**COUNTY OF SONOMA
DEPARTMENT OF TRANSPORTATION AND PUBLIC WORKS**

CONTRACT CHANGE ORDER NO. 3

CONTRACT FOR: 2021 Culvert Replacement Program

Change In Plan (RFCOs 8001, 8002, 8003, 8006)

Change Order No. 3, Sheet 3 of 3

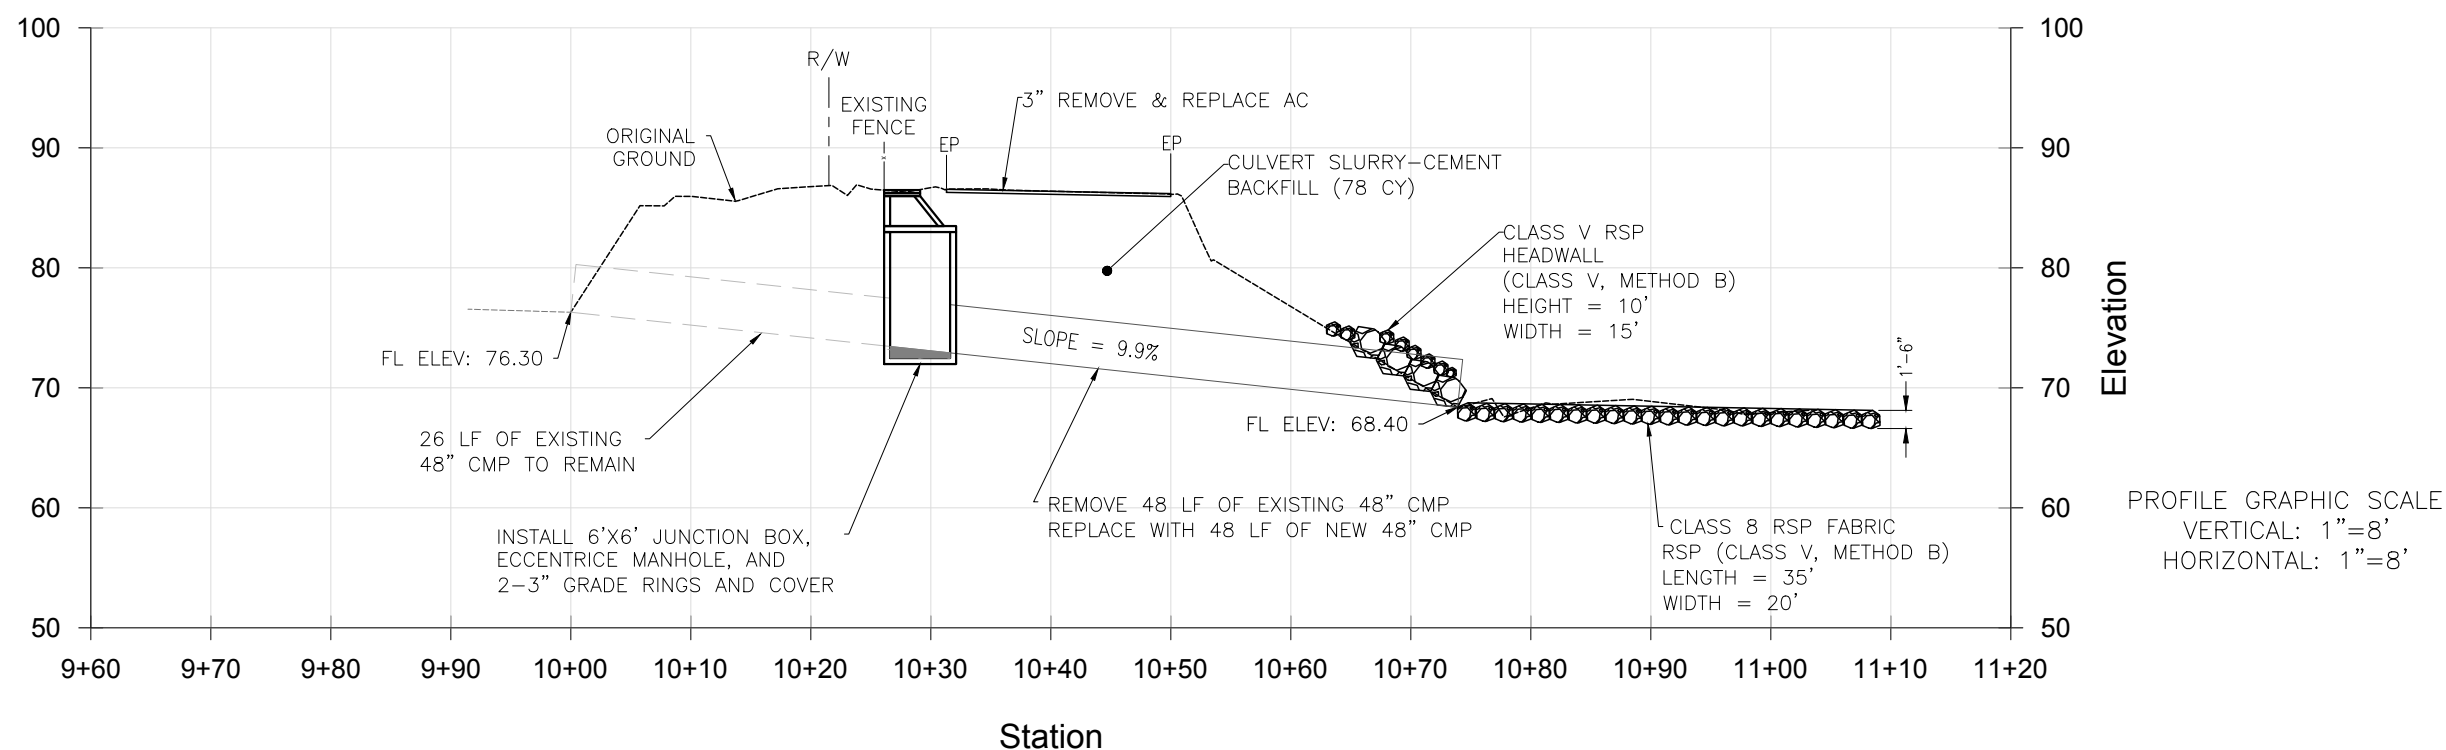
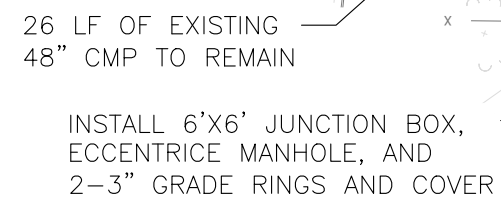
Construct the work at Location 9, Summerhome Park Road, in accordance with the attached, revised plan titled, "Plan & Profile (Summerhome Park Rd) Add1 (rev1)." The changes include downsizing the culvert from a 60" CMP to a 48" CMP, construction of a manhole junction box, and procurement and delivery of the 60" CMP to the County roadstock yard. Additional contract time is added for inefficiencies related to material procurement and permit requirements causing nonconcurrent construction of Location 9.
